ARCHITECT'S SUPPLEMENTAL INSTRUCTIONS

Data lava di	L.,, - 10, 0000
Date Issued:	June 19, 2020
Project:	Intermountain Healthcare Tooele Valley Dialysis Clinic Expansion 2356 North 400 East, Suite #102 Tooele, Utah 84074
Architect's Supplemental Instructions:	ASI #10
To:	Saunders Construction 1113 South 500 West Bountiful, Utah 84010

Electrical ASI #10

__ETOO1

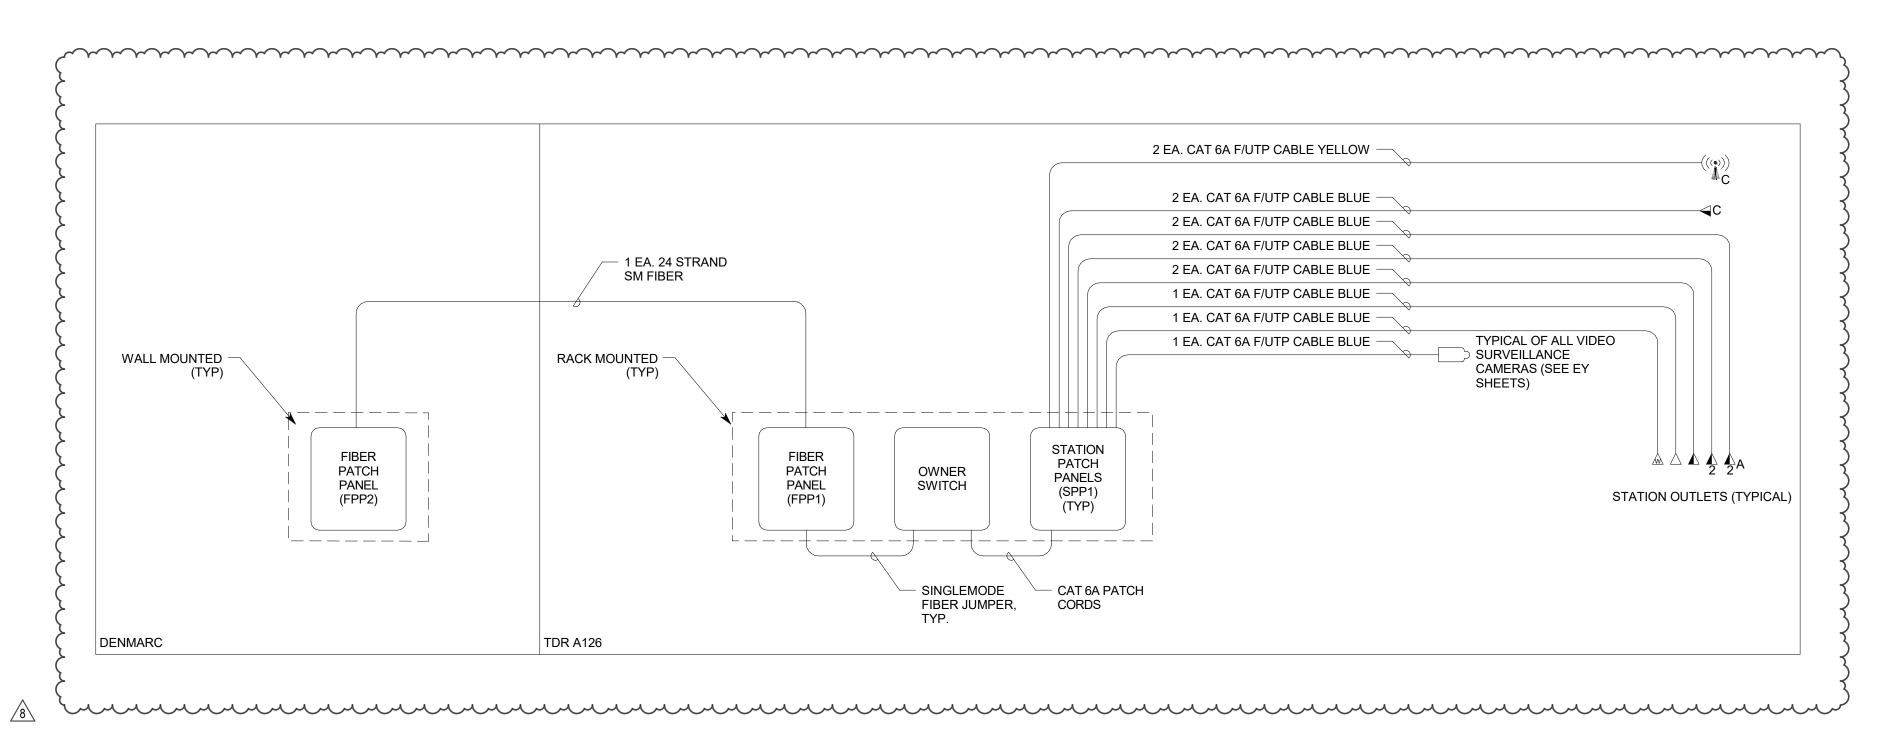
Item Number	Description	
1	As requested by the Owner and Intermountain IT team- provide wall mounted fiber panel and 24 strand fiber from TDR to demarc. See attached Electrical sheets ET001 & ET601 with revisions shown clouded.	
2	See attached Electrical ASI #10 memo from Spectrum Engineers.

1. Added FPP2 wall mounted fiber panel for fiber to demark **ET601**

ET601

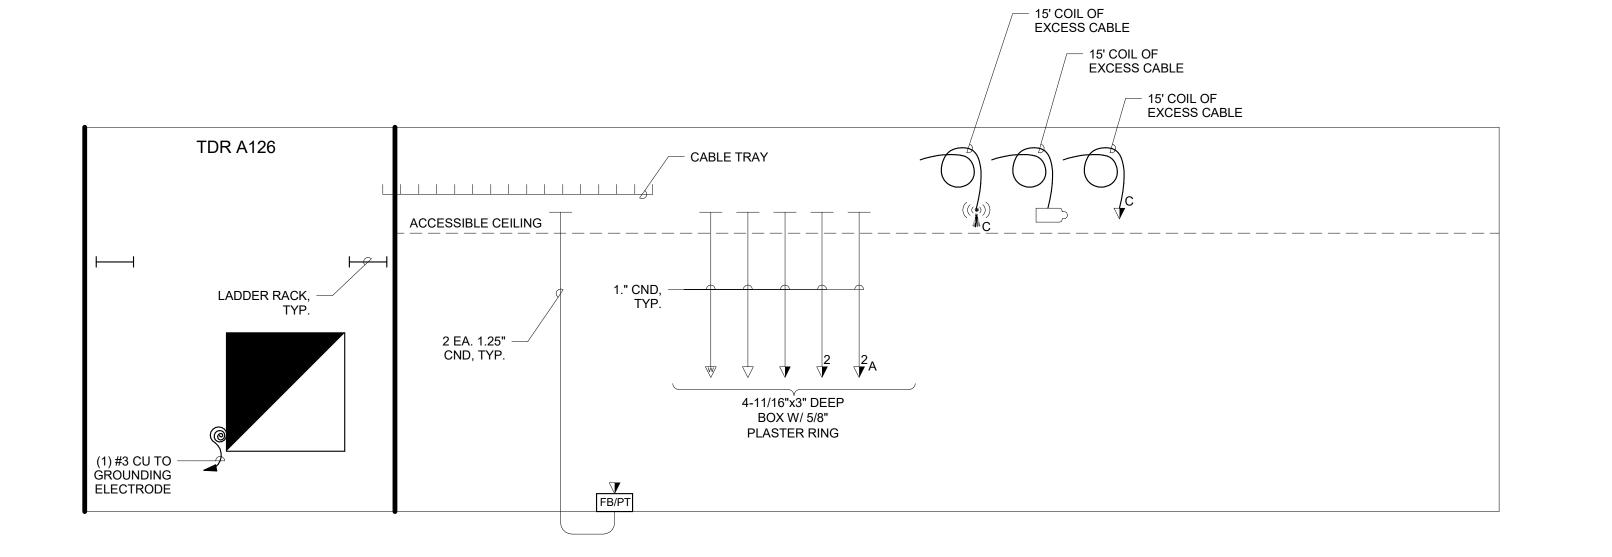
1. Added 24 strand fiber from TDR to demarc.
